CITY OF ALBUQUERQUE

Re: Murphy Express
1358 Wyoming Blvd NE
Traffic Circulation Layout
Engineer's Stamp 10-27-17 (J20-D037)

Based upon the information provided in your submittal received 10-24-17, the above referenced plan cannot be approved for Building Permit until the following comments are addressed:

TCL-1

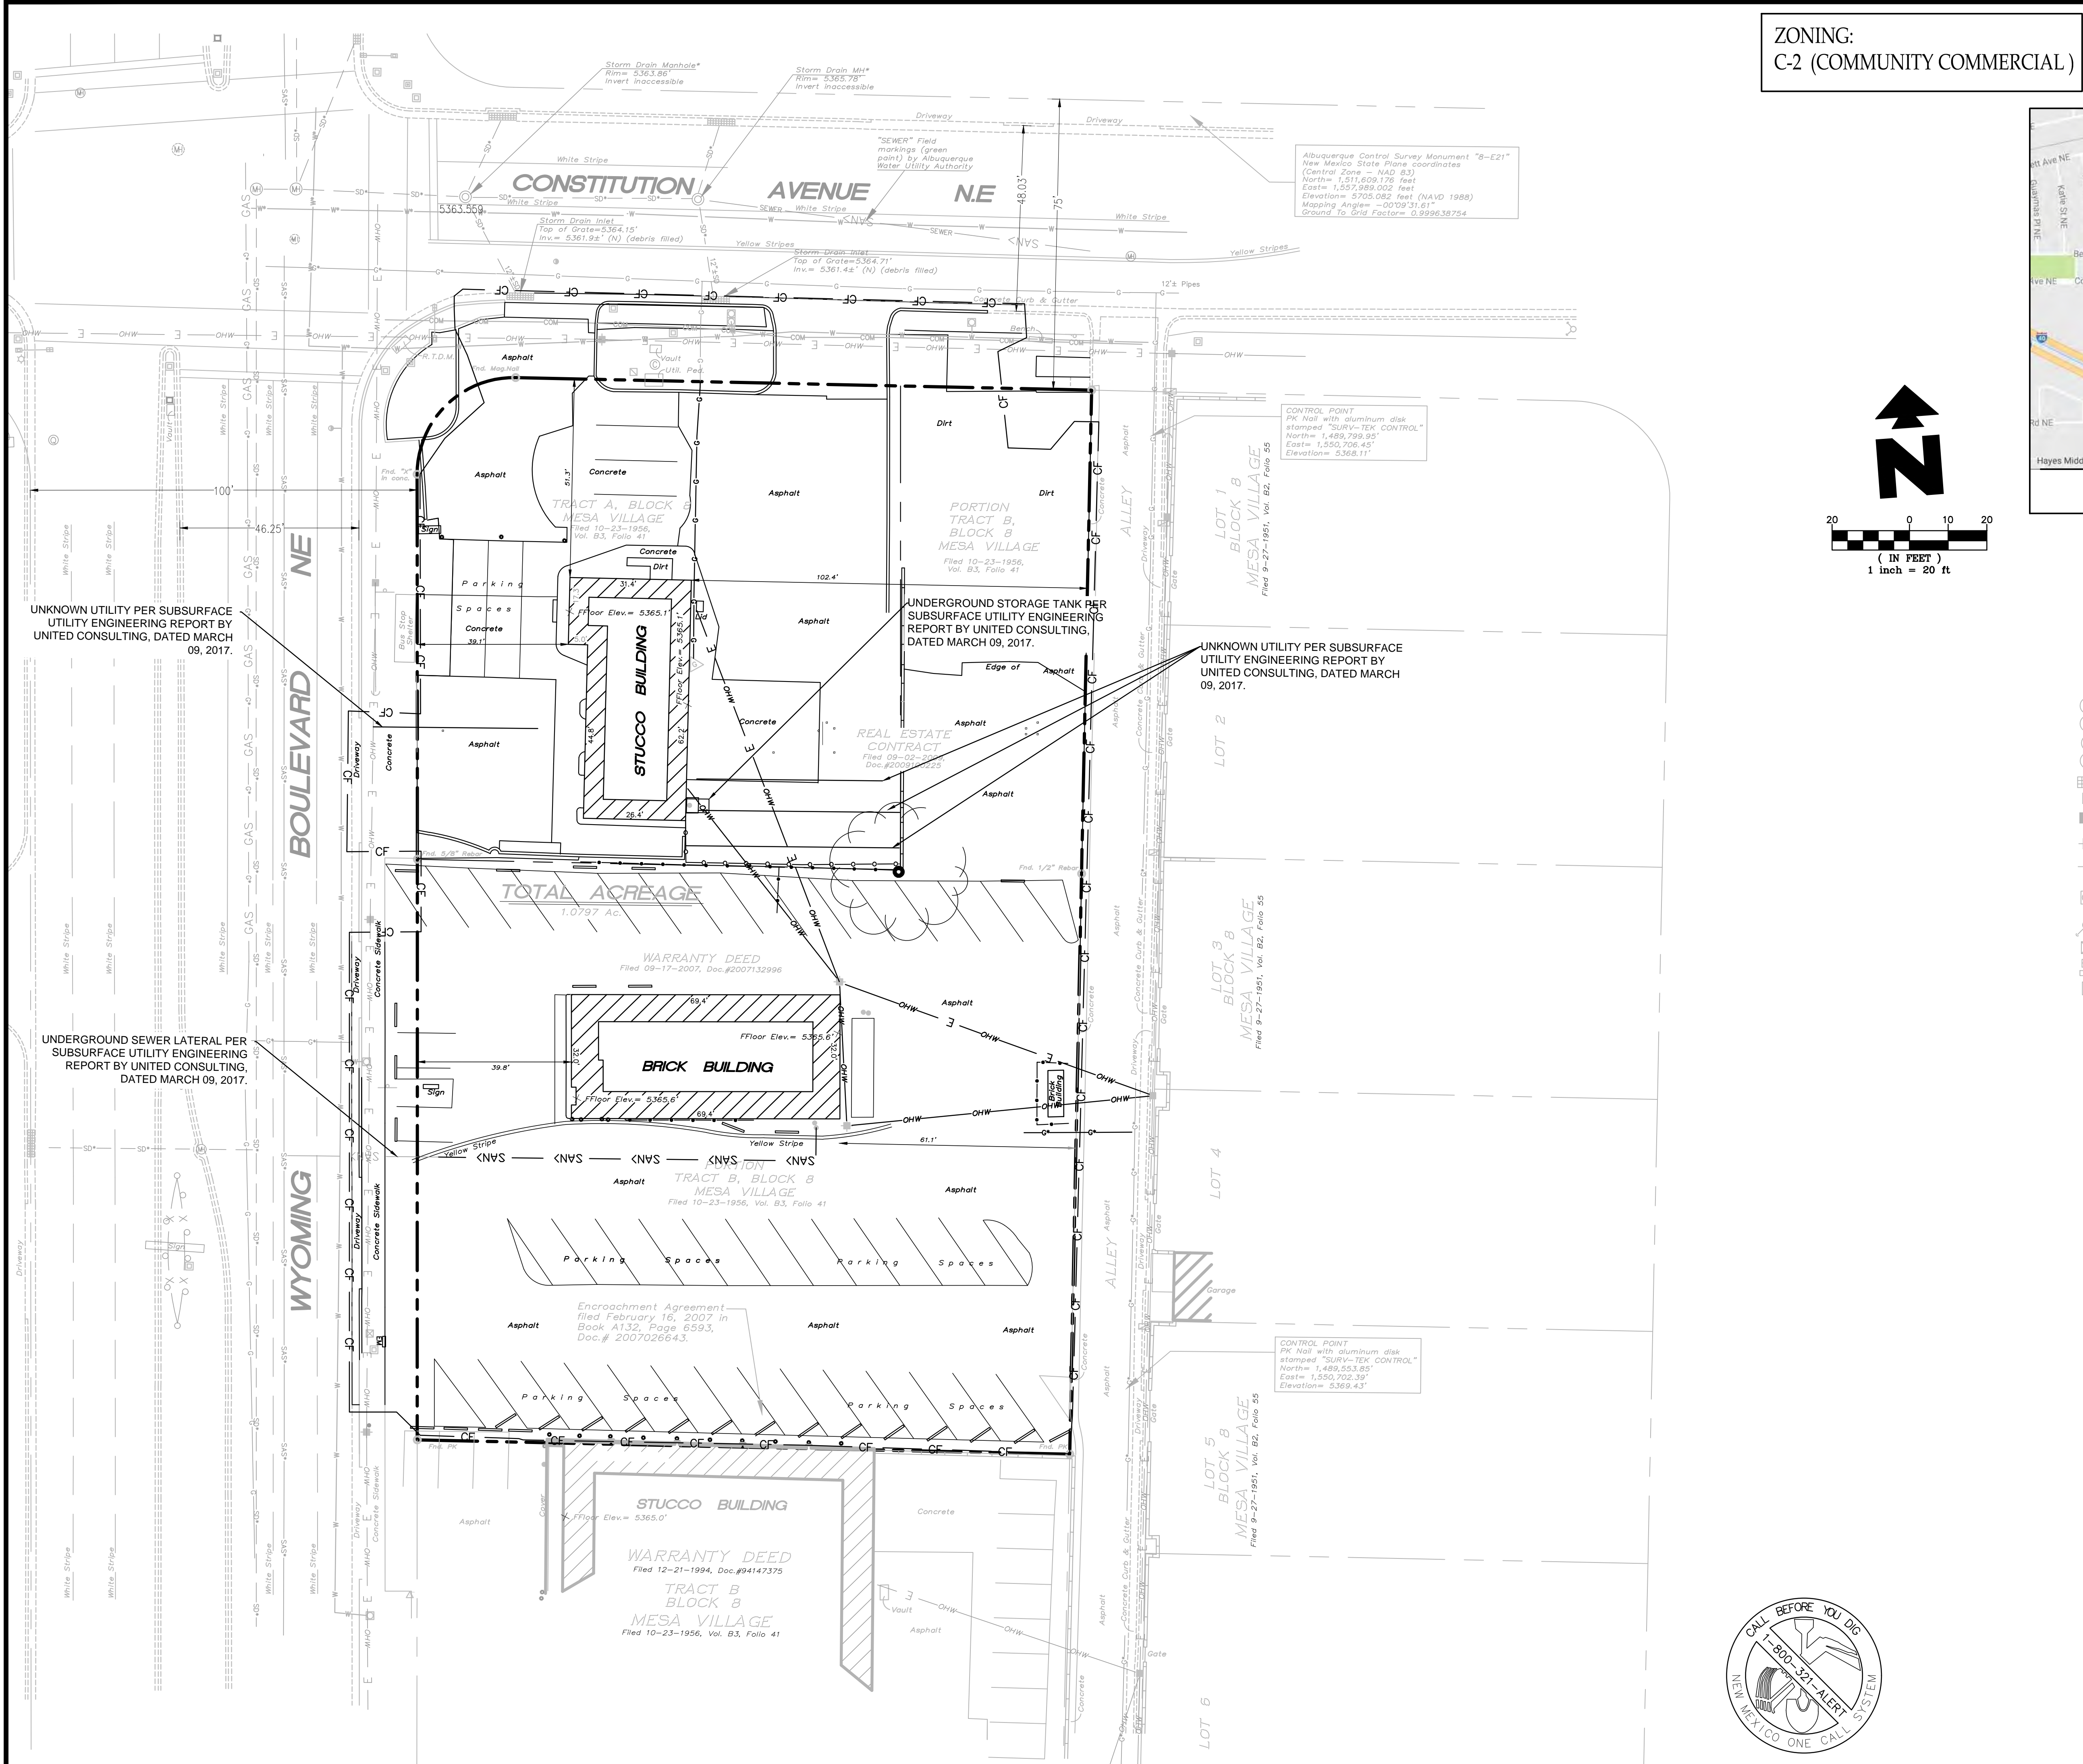
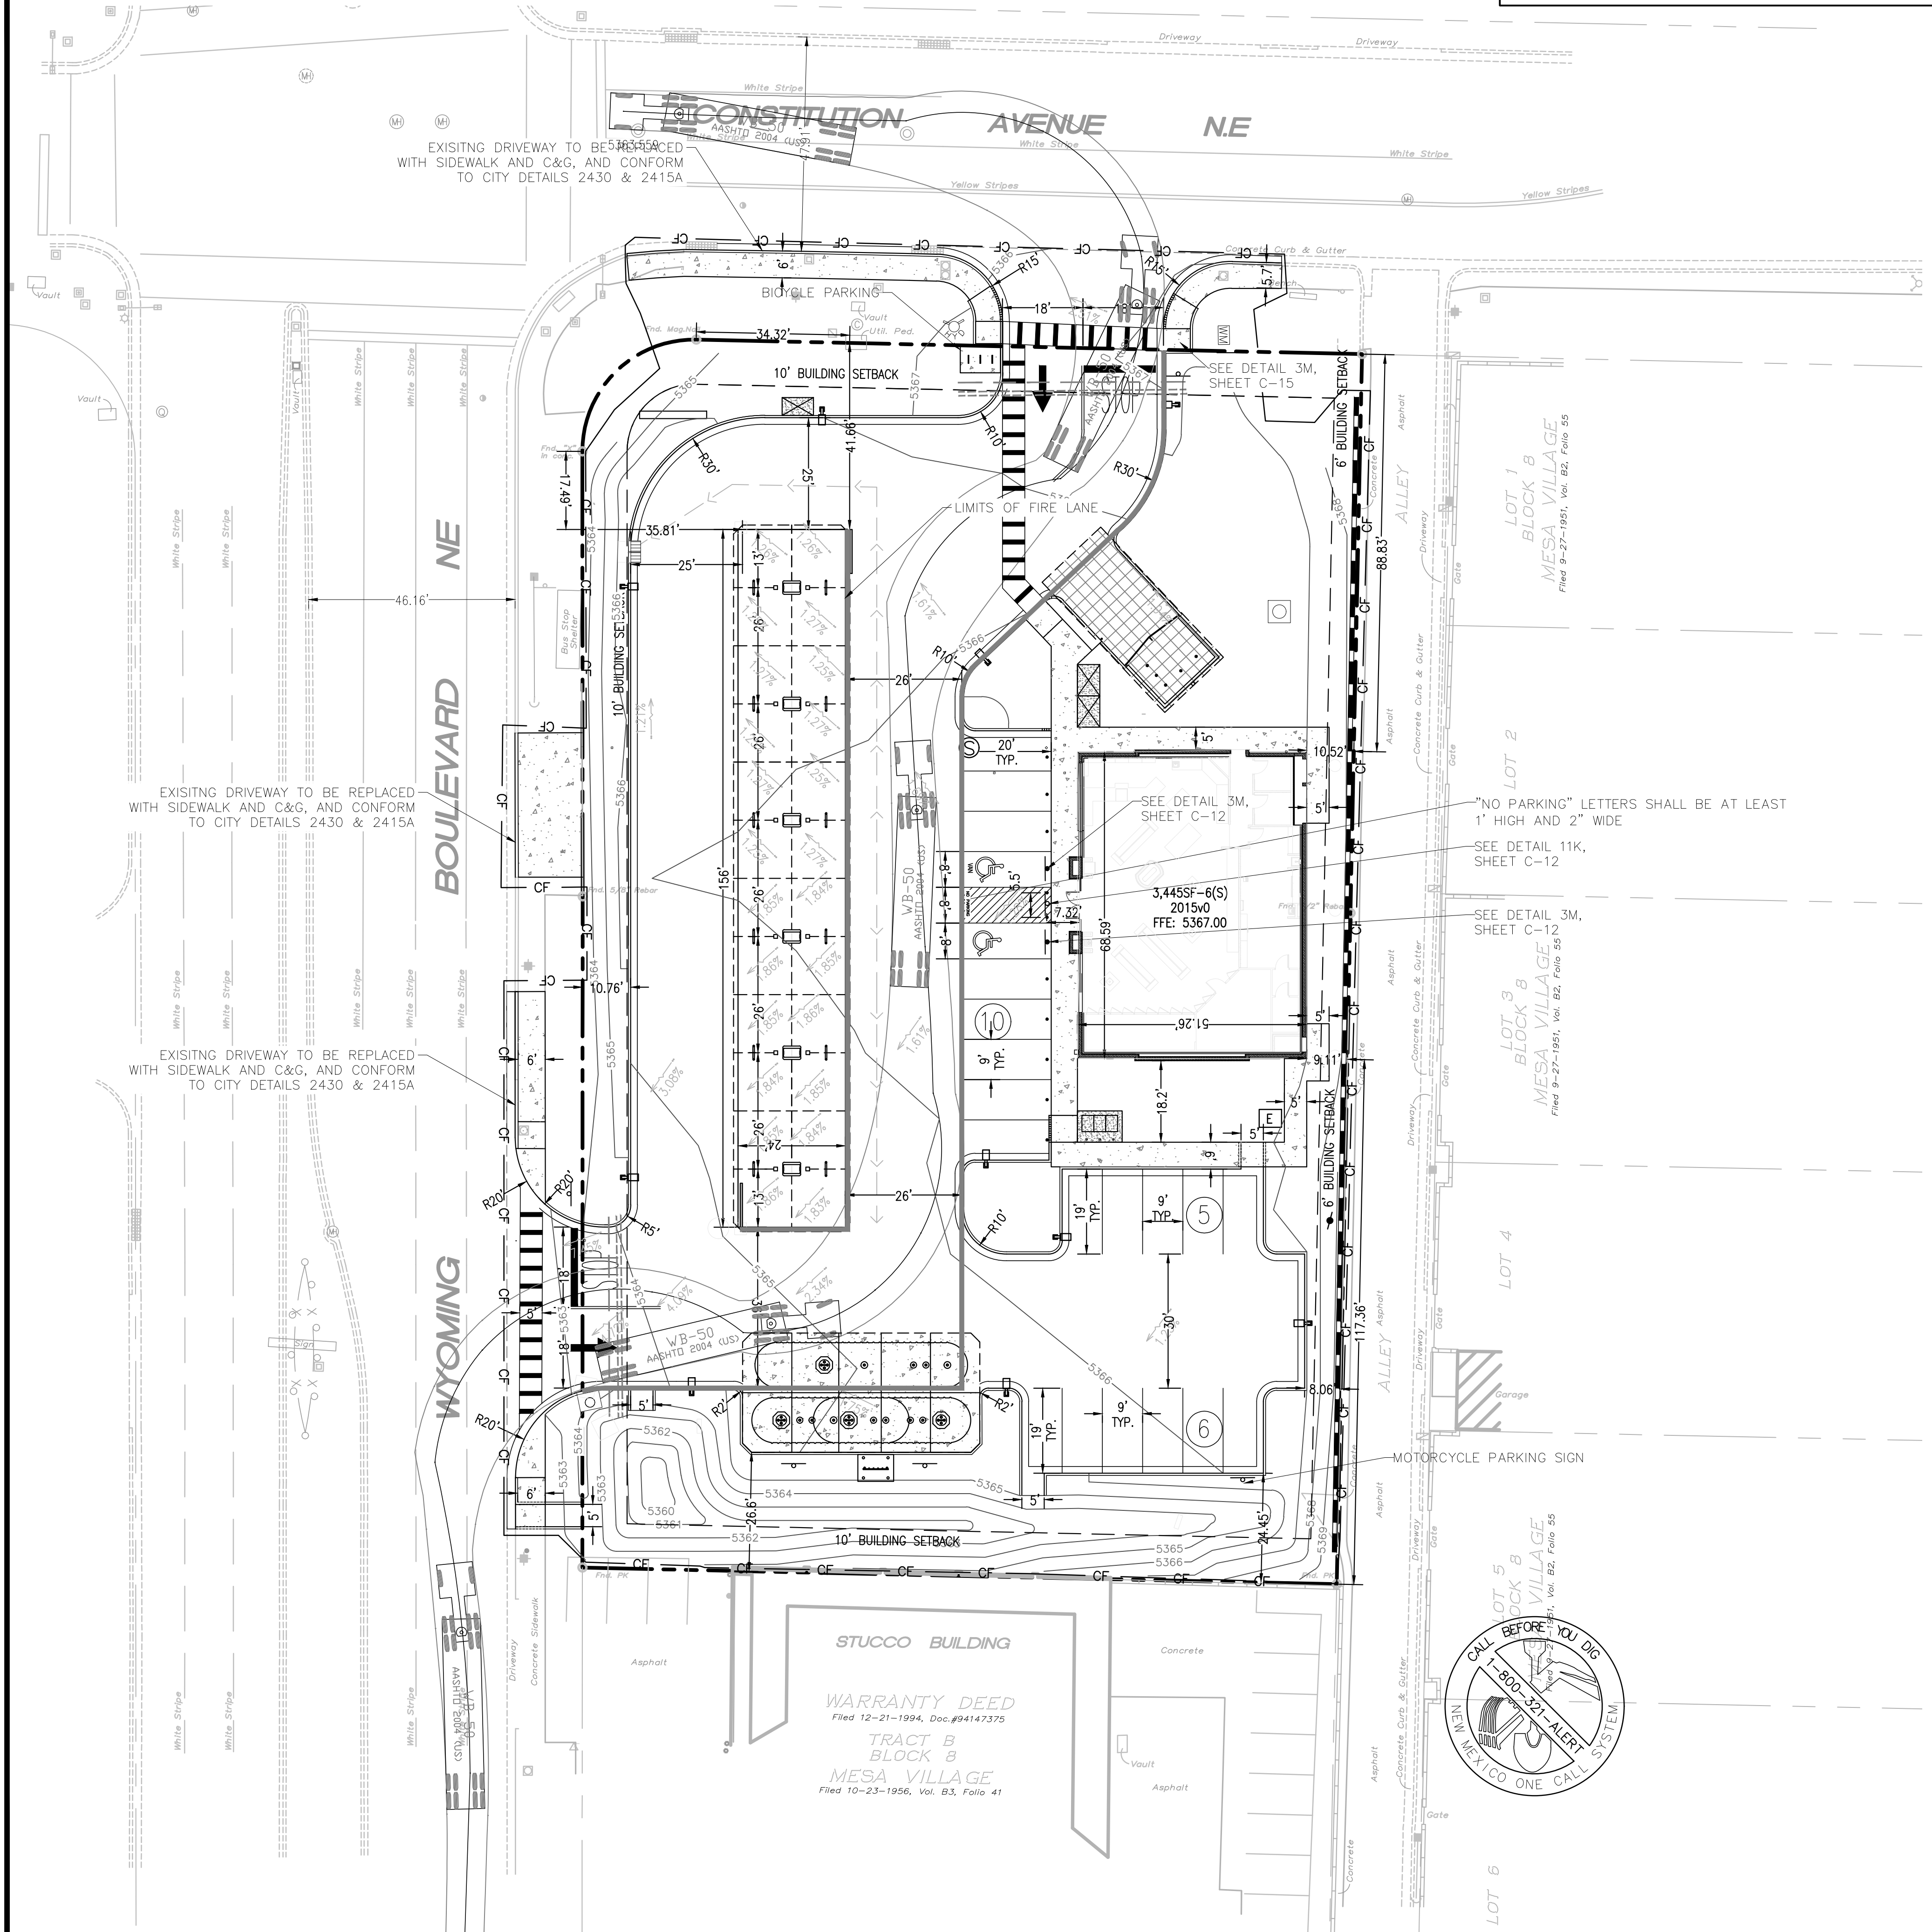
1. The no parking sign in the ADA access aisle may obstruct the ADA path. This sign is not needed.
2. ADA accessible pedestrian pathway should not be placed behind parking space or adjacent to a vehicular way. Vehicle and pedestrian/wheel chair conflicts should be avoided as much as possible. The pedestrian path next to the north entrance needs to be protected with curb or header wall.
3. Provide a min 6" or max 8" high concrete barrier curb or other acceptable barrier between landscaping and parking areas and/or drive aisles. Please call out detail and location of barrier curb. The parking next to the building should have parking bumpers. The plan refers to M3 on sheet C-12, but I am not seeing a M3.
